C2M0280120D

Transition Guide

Wolfspeed  SEPTEMBER 2024

C2M → C3M | TRANSITION BENEFITS

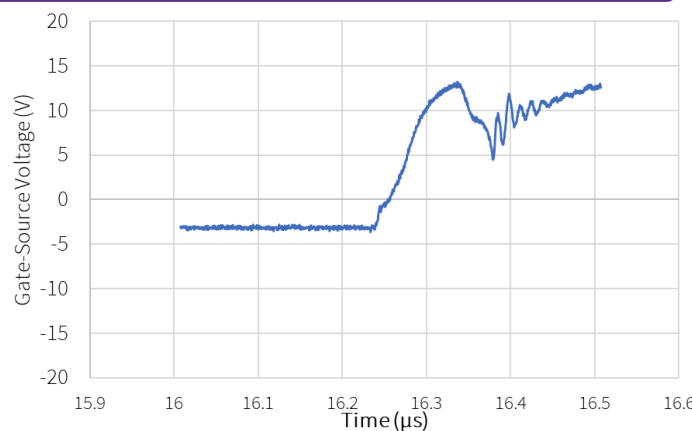
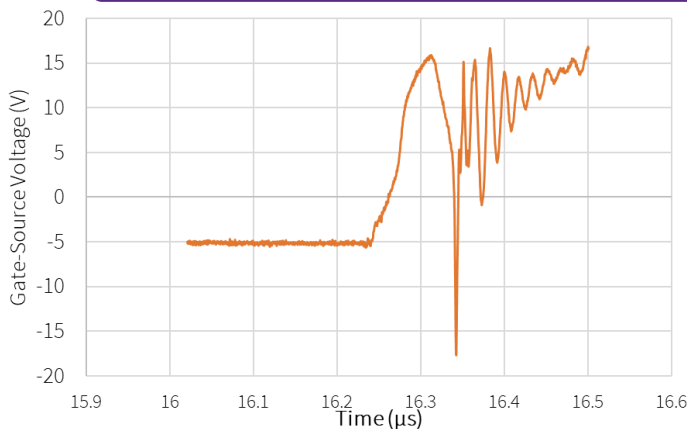
I_{DS} at turn-on

- ✓ Reduced peak recovery current
- ✓ Reduced Q_{rr}
- ✓ Softer body diode
- ✓ Reduction in ringing
- ✓ Improved EMI performance

V_{GS} at turn-on

- ✓ Ciss/Crss ratio improvement reduces gate oscillation
- ✓ Increased margin allows for more aggressive switching speeds to reduce E_{ON} & E_{OFF}
